**Subject: Beaver Valley Power Station, Unit No. 1  
BV-1 Docket No. 50-334, License No. DPR-66  
Supplemental Information – BVPS Unit No. 1 Steam Generator Tube  
Rupture Analysis Update**

Beaver Valley Power Station, Unit No. 1  
Supplemental Information – BVPS Unit No. 1 Steam Generator  
Tube Rupture Analysis Update  
L-07-042  
Page 2

### **Summary Results: Updated Steam Generator Tube Rupture (SGTR) Analysis for Beaver Valley Power Station Unit 1 (BVPS-1)**

**Figure 5-1**  
**Pressurizer Level**

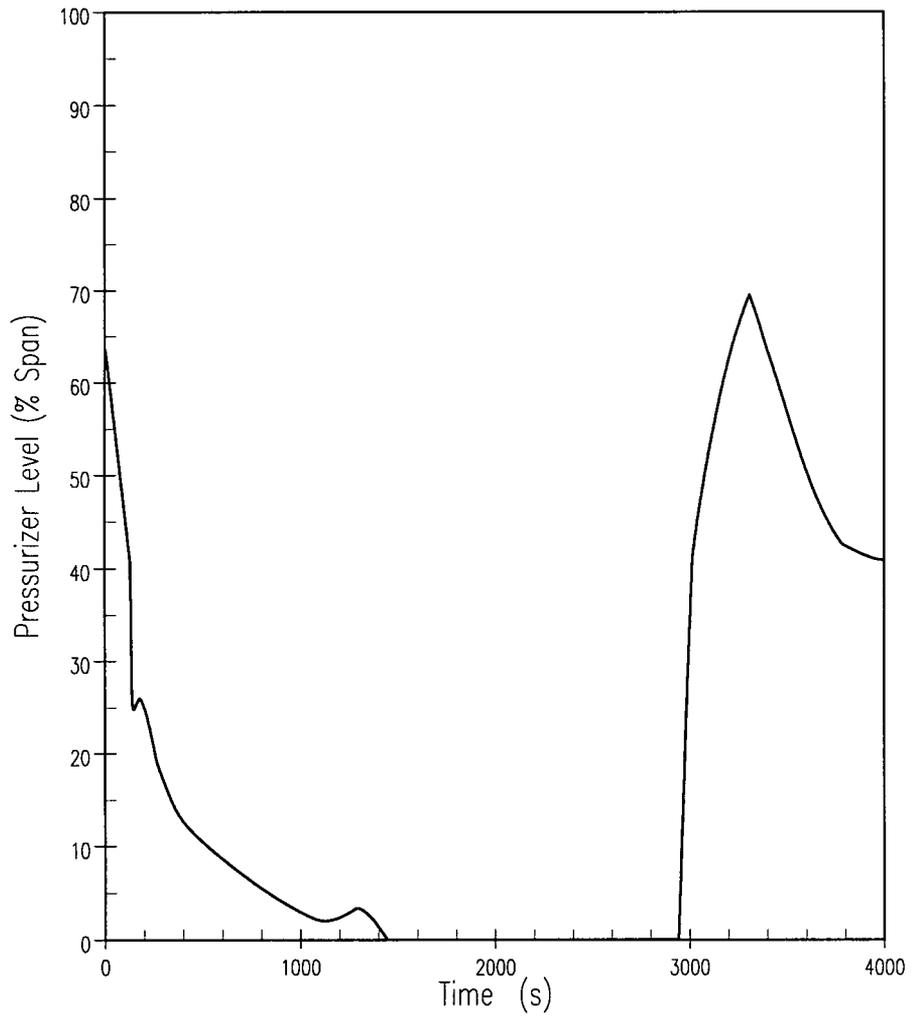
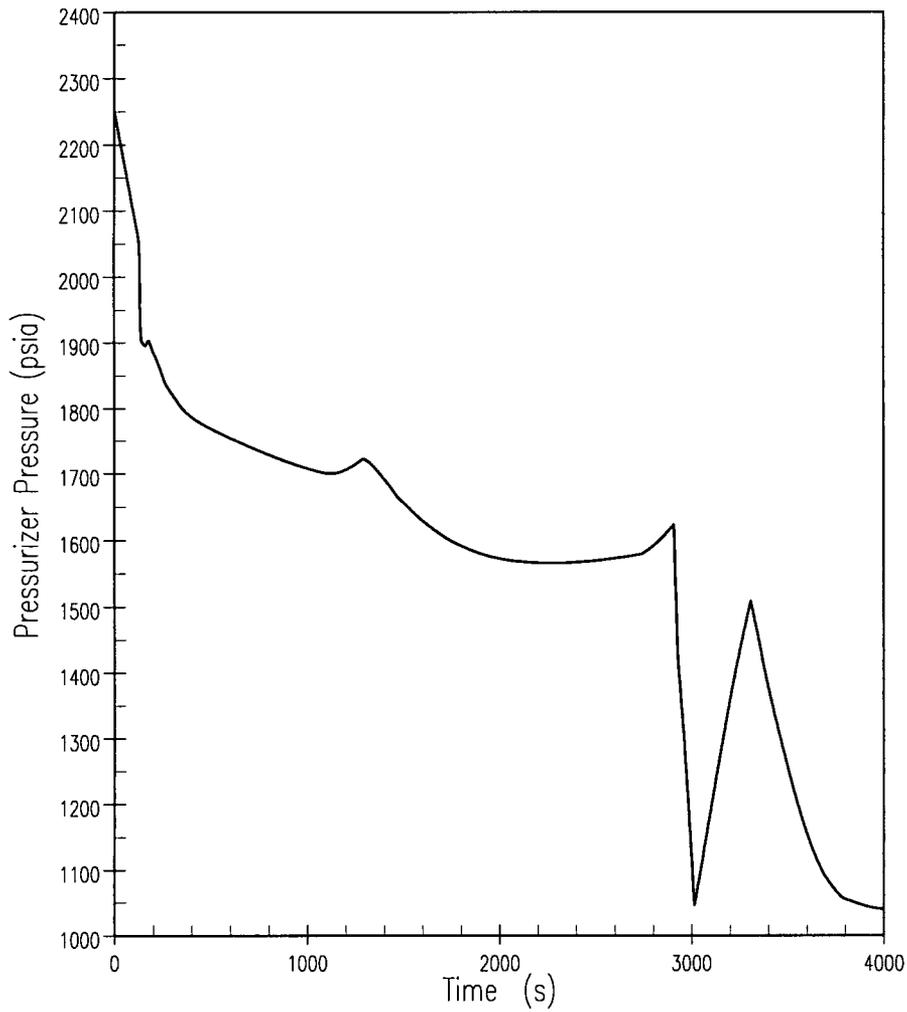
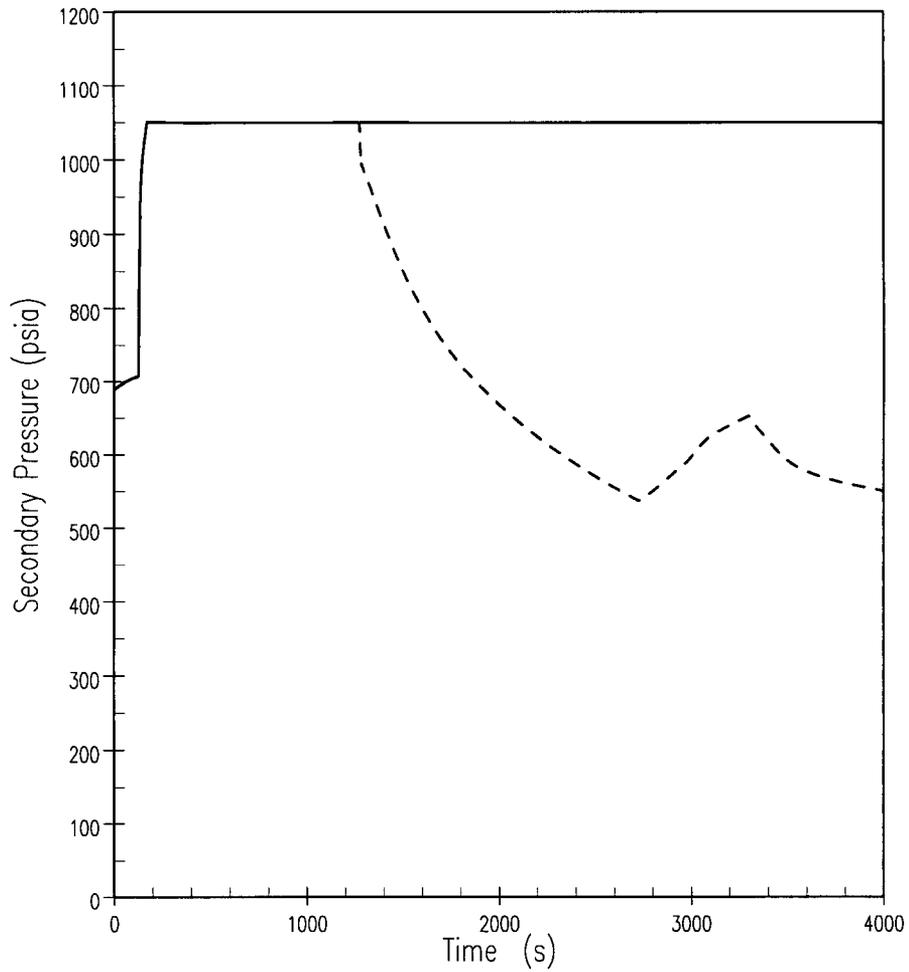
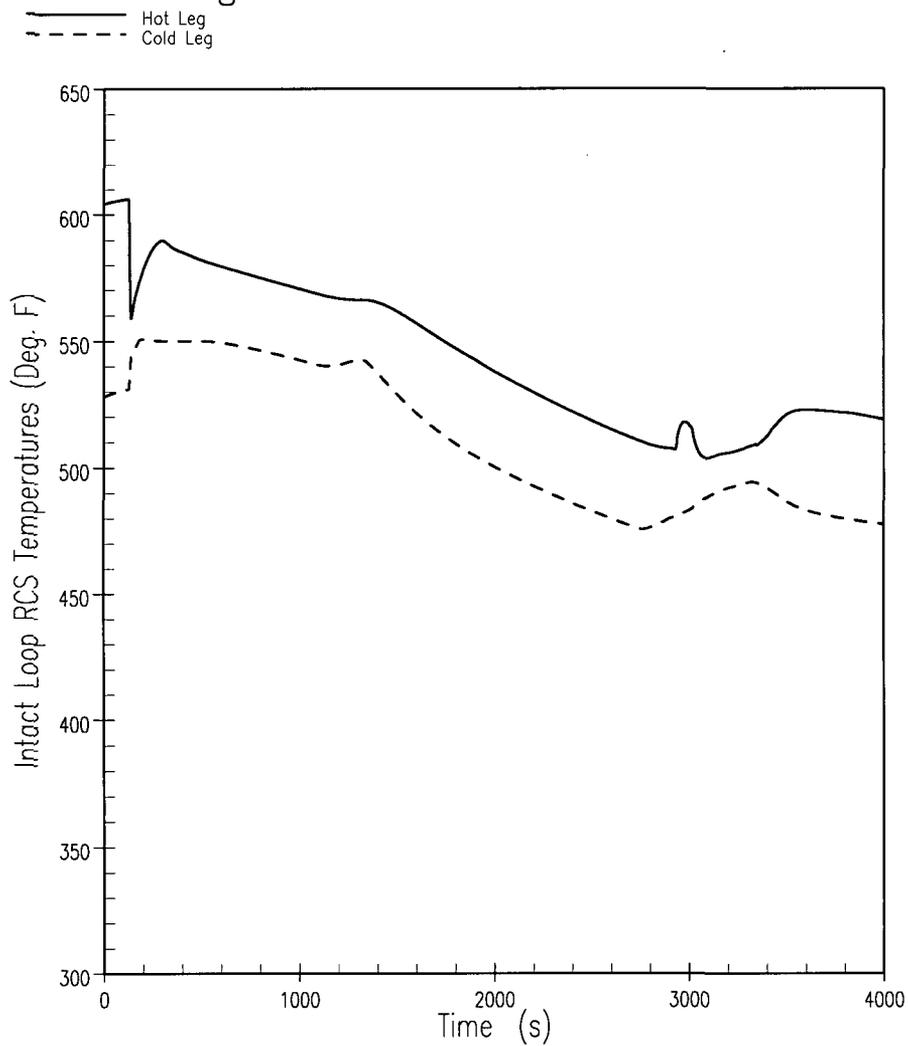
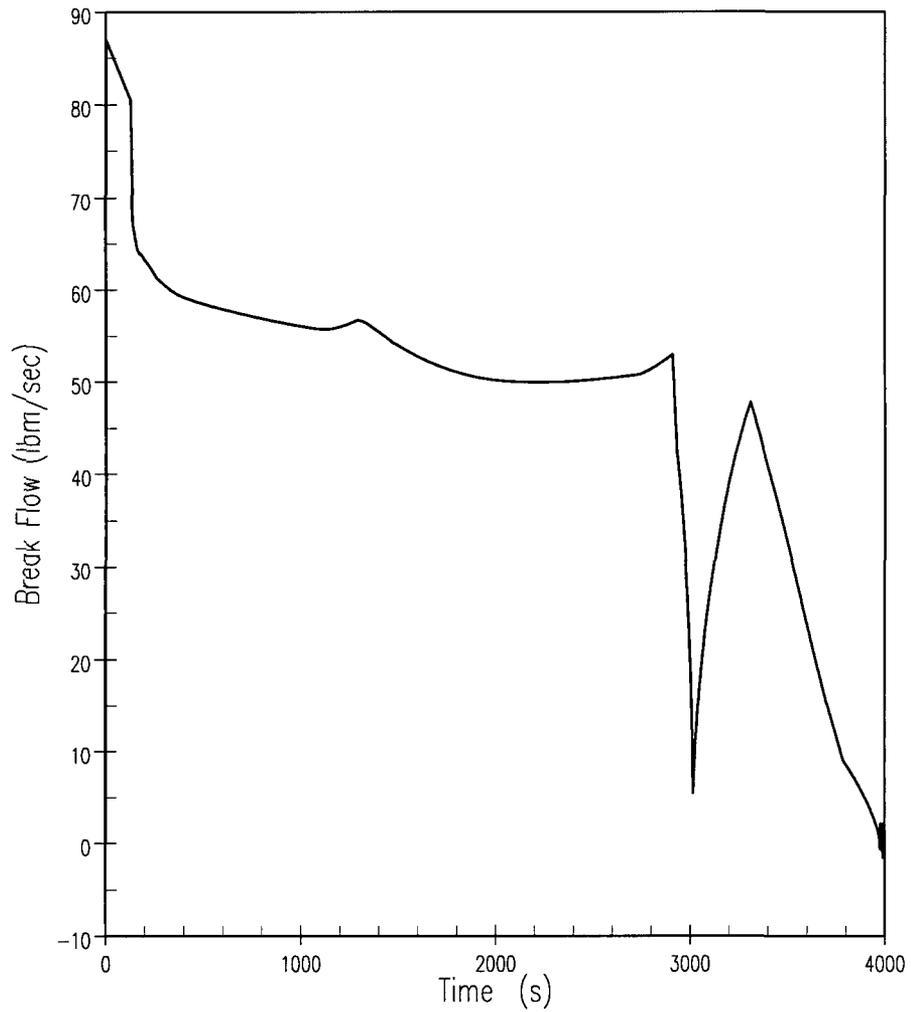
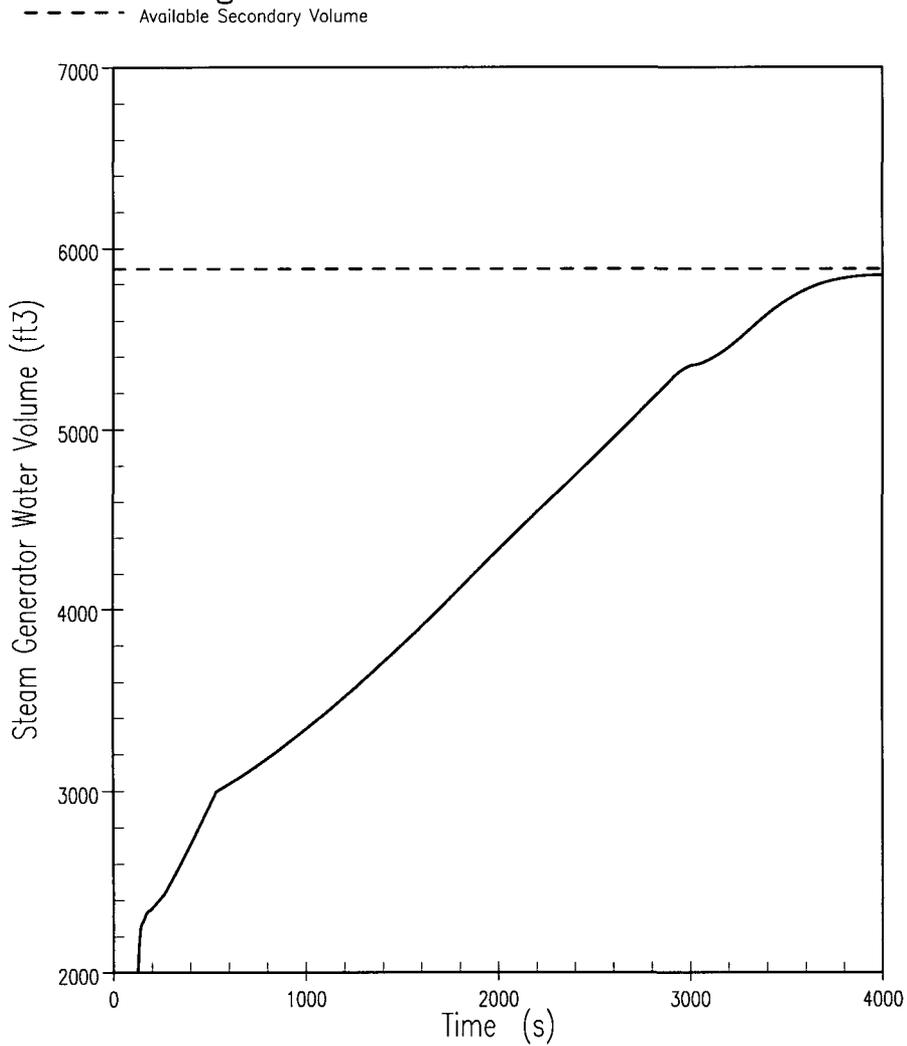
- Response to RAI question B.1 (Table B.1) and RAI questions 5 and 6 were updated to identify the termination of the primary-to-secondary break flow for EPU conditions and the extension of the time period from 8 hours to 24 hours due to the reduced valve capacities.
- Changes were made to Table 5-2 "BVPS-1 Margin to Overfill Analysis Sequence of Events" to account for the SGTR re-analysis for BVPS-1.
- Figures 5-1 through 5-6 were revised to reflect the SGTR re-analysis for BVPS-1.

The SGTR operational response analysis for EPU conditions with RSG included cases to provide thermal-hydraulic tube rupture data for use in radiological dose consequence analysis and for evaluation of margin to overfill. The sequence of events for these cases is shown in Tables 5-1 and 5-2, respectively. The sequence of events tables show that termination of the event (i.e., termination of primary-to-secondary break flow) occurs at 3988 seconds (approximately 66.5 minutes) and ~~3578~~ **3976** seconds (approximately ~~60~~ **66** minutes), respectively, for EPU conditions with RSGs. For BVPS-1, the termination time used in the radiological dose consequence analysis was increased to allow additional operator action time for the operator to isolate the failed-open steam generator atmospheric dump valve (ADV) on the ruptured steam generator. Figures 5-1 through 5-6 show the response of pressurizer level, pressurizer pressure, intact and ruptured SG pressure, intact loop RCS temperatures, primary-to-secondary break flow, and ruptured SG water volume for the margin to overfill case. The response to Question 6 provides information regarding the analysis performed in the 1990's for current power conditions that established a break flow termination time of 51 minutes.
